AMENDMENT OF SOLICITATION/MODIFICATION OF CONTRACT				1. CONTRACT ID CODE	PAGE 1 OF 3 PAGES
2. AMENDMENT/MODIFICATION NO. AMENDMENT NO. 0001		3. EFFECTIVE DATE 05/02/14	4. REQUISITION/PURCHASE REQ. NO.	5. PROJECT NO. (If applicable) 14-0105	
6. ISSUED BY CODE		mks	7. ADMINISTERED BY (If other than Item 6) CODE		See Item 6
8. NAME AND ADDRESS OF CONTRACTOR (No., street, county, State and ZIP Code)			(X)	9A. AMENDMENT OF SOLICITATION NO. N40085-14-R-0105	
			X	9B. DATED (SEE ITEM 11) 04/11/14	
				10A. MODIFICATION OF CONTRACT/ORDER NO.	
				10B. DATED (SEE ITEM 11)	
CODE		FACILITY CODE

14-0105 Repair BEQ, Building HP509

1. Delete original drawings listed below and replace with the attached REVISED DRAWINGS:

NAVFAC DRAWING NO. 60011983
 NAVFAC DRAWING NO. 60011991

ATTIC ELECTRICAL NEW WORK PLAN

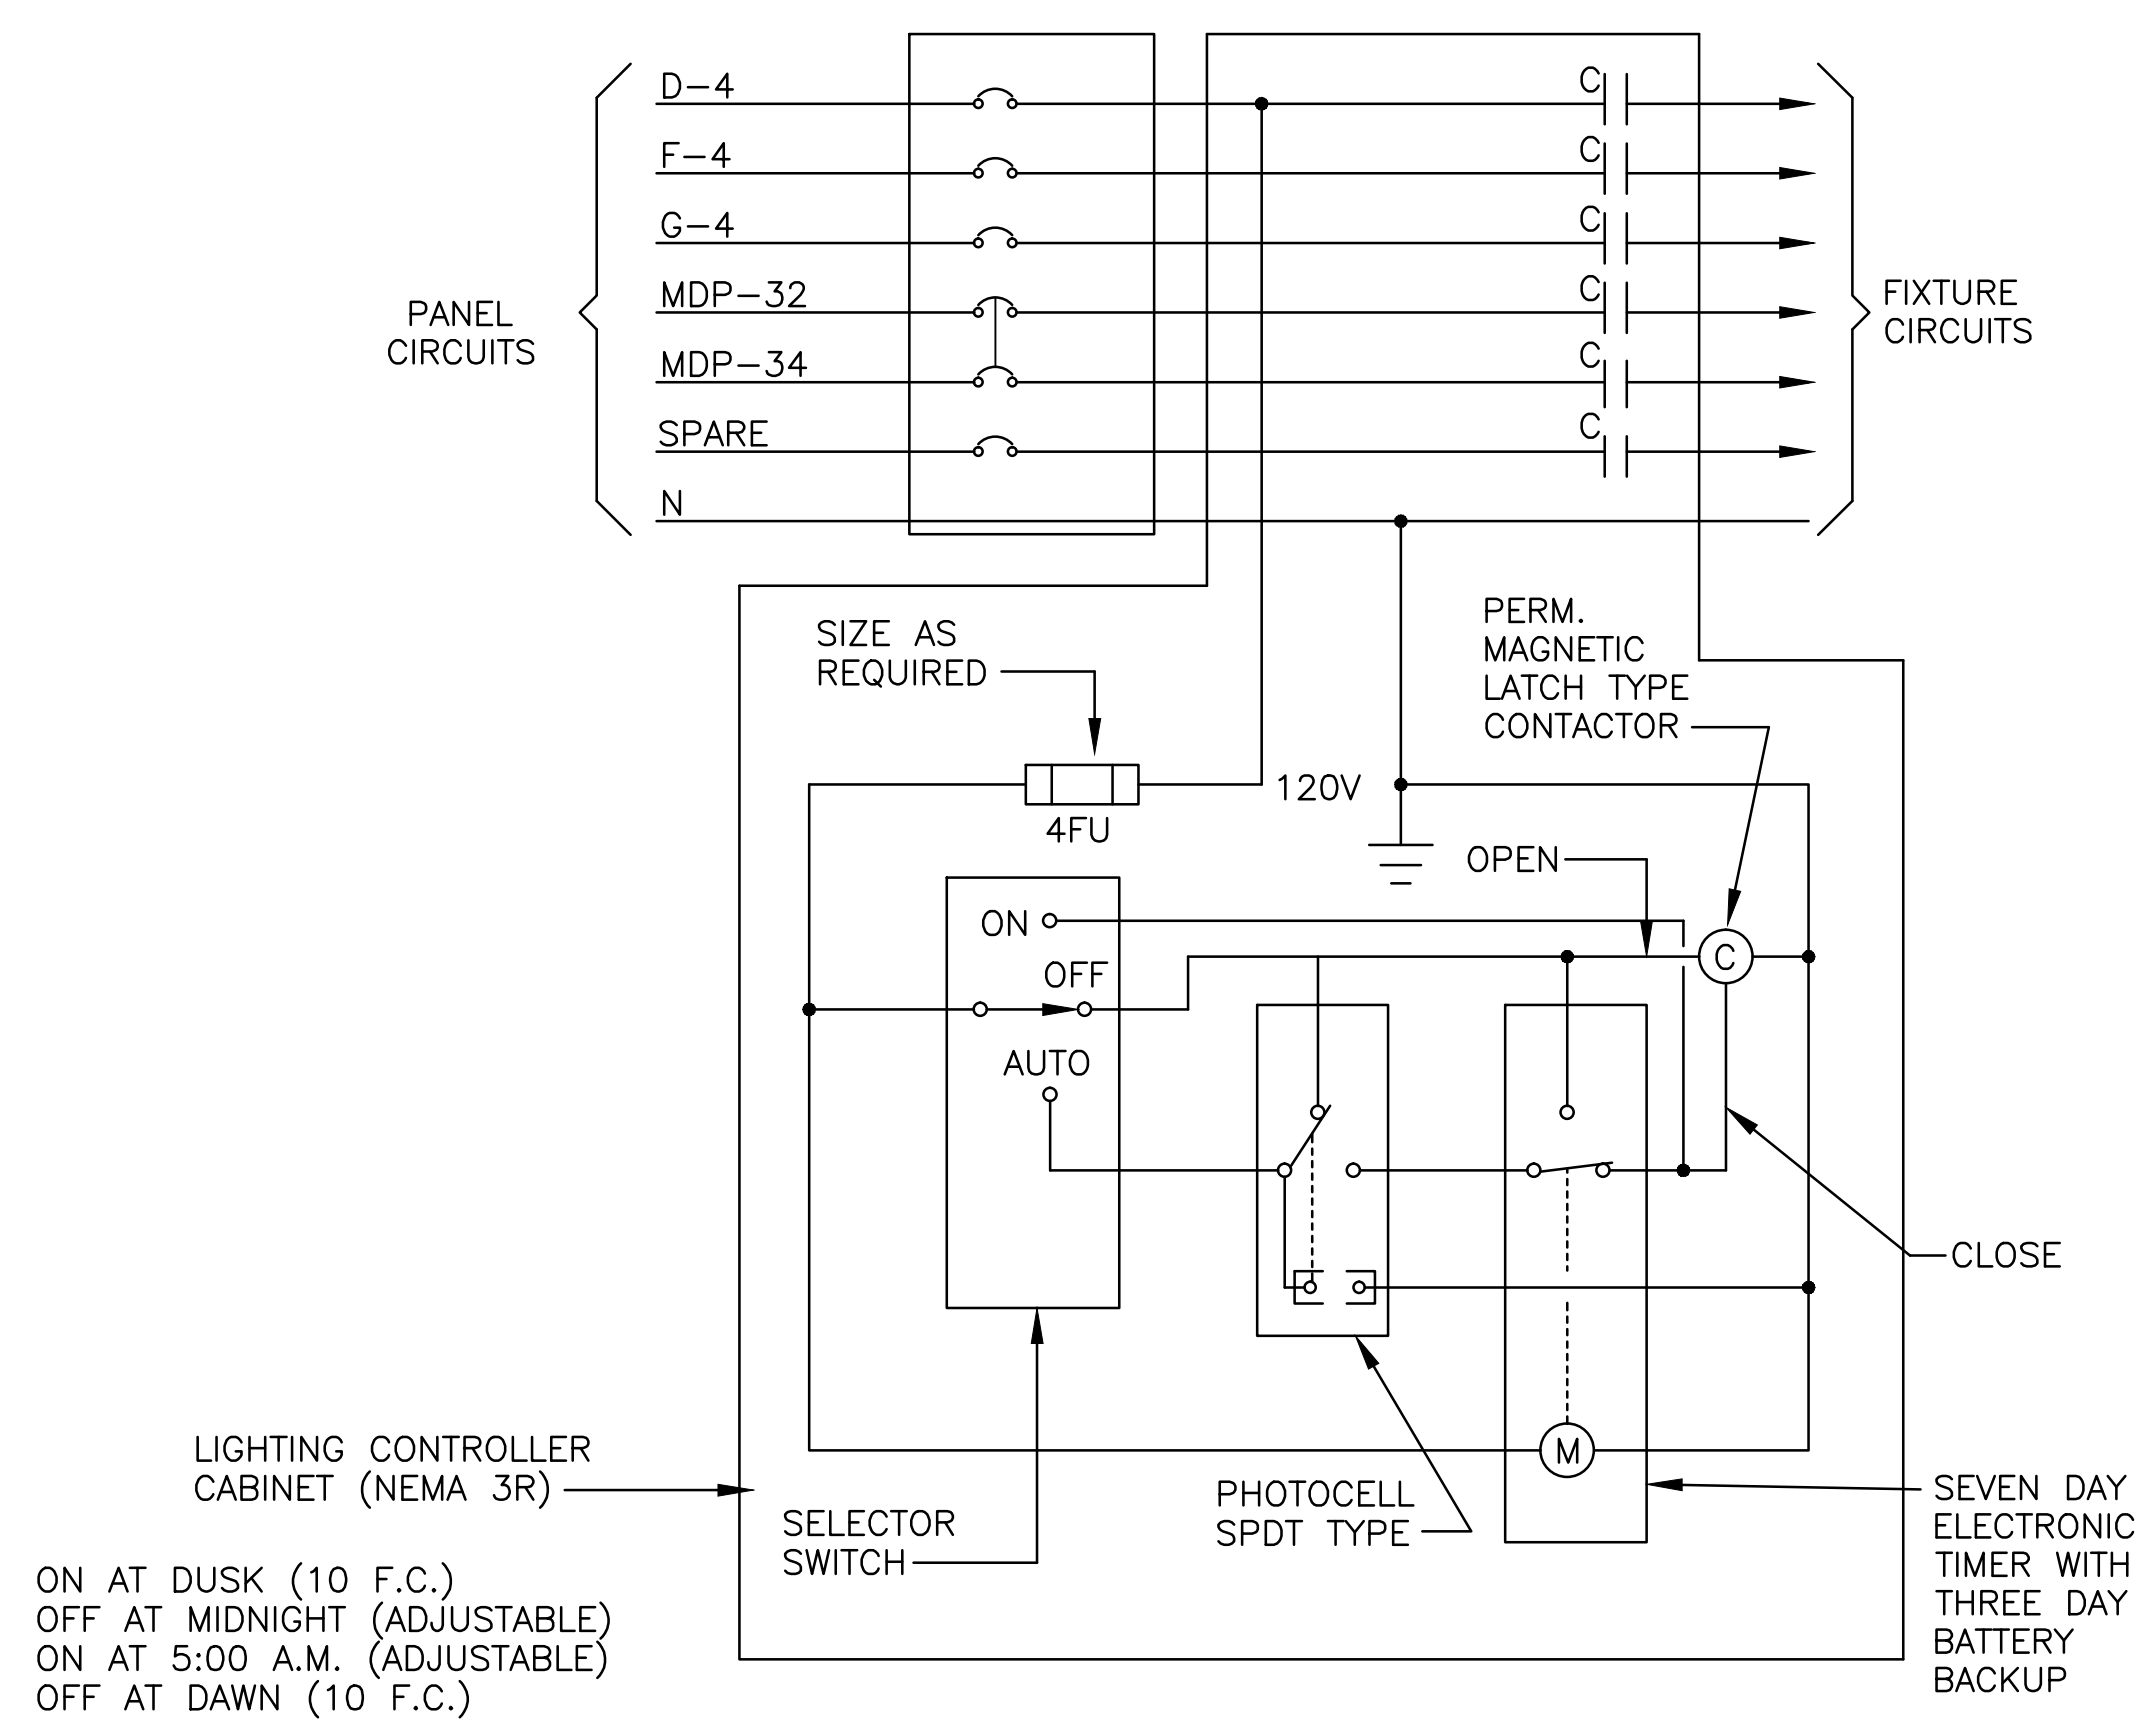
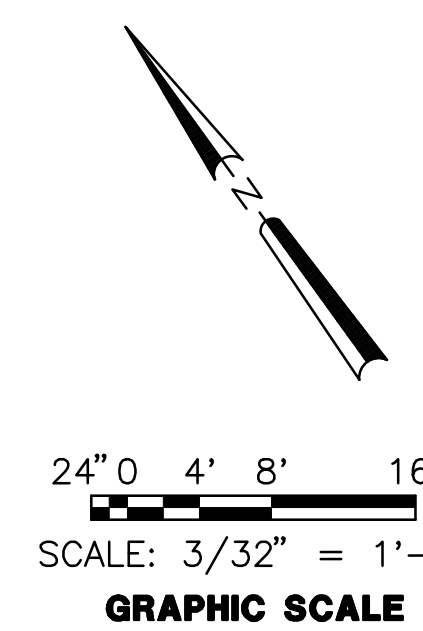
04/28/14 ELECTRICAL UPDATE		E-102	
		DEPARTMENT OF THE NAVY NAVAL FACILITIES ENGINEERING COMMAND MARINE CORPS BASE CAMP LEJEUNE, NORTH CAROLINA	
DES. R. ALVAR DR. C. COOPER CHK. J. BONGIORNO SUBMITTED BY:		REPAIR BEQ BUILDING HP509	
DESIGN DIR. APPROVED: PWO OR OICC DATE		ATTIC ELECTRICAL NEW WORK PLAN AND SCHEMATIC NAVFAC DRAWING NO. 60011983	
SATISFACTORY TO: DATE		CONST. CONTR. NO. N40085-12-B-0123 SCALE: AS NOTED SPEC. 05-12-0123 SHEET 78 OF 87	
6 FEBRUARY 2014
